Courtyard layout · REVISED 3 Nov 2026 · a level floor, movable furniture, the enclosure on the kitchen wall in front of the sink window · Taif / Palm House V8.2

Owner decisions 3 Nov 2026 (the V8.0 layout of 1 Nov 2026 revised: no step, no built-in benches, the enclosure moved east, the TV moved south) · clear dimensions between finished faces · the data in `3d/character.yaml` `courtyard_layout` (built in the 3D) and `studies/air_system.typ` (the grille) · every size assumed; nothing here is for construction

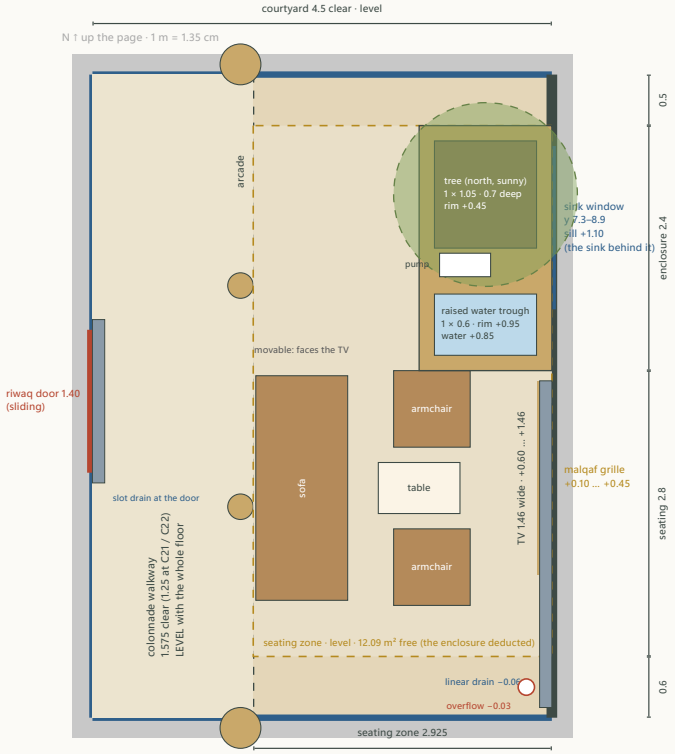
- The step, the nosing, the riser light and the three built-in benches are **removed**; the floor is level; the furniture is movable. The enclosure left the north side (the women's majlis glass is free) for the kitchen wall in front of the sink window; the TV and its surround moved 0.05 m south, the grille with them (`studies/air_system.typ`). The data: `3d/character.yaml` `courtyard_layout` (built in the 3D: `character_3d.py`, checked in `check_3d.py`); the plan marks in `design_gf.typ`; the drains in `studies/plumbing.typ` (the rain system).

2 · Movable furniture for 4–6, facing the TV

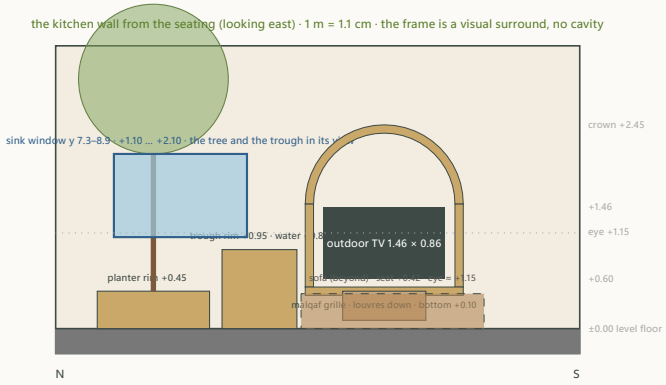
- **Modern movable pieces** (the owner chooses them): a **3-seat sofa** 2.2 × 0.9 with its back to the colonnade edge facing the TV on the east wall, **two armchairs** beside the low **table** 0.8 × 0.5 (meals, coffee): **5 seats**, 6 with two stools; everything can be moved for a big meal or cleaning. Outdoor-rated fabrics, cushions stored in the hospitality kitchen's cupboard.
- **Seating area gained:** the level zone east of the soffit edge from the north strip to the south strip is 15.21 m²; less the enclosure (3.12 m²) **12.09 m² free**, against 10.53 m² in the sunken pit: **+1.56 m² (+15 %)**; and the colonnade strip (9.92 m²) is now at the same level, so the whole 28.35 m² floor is one usable surface.
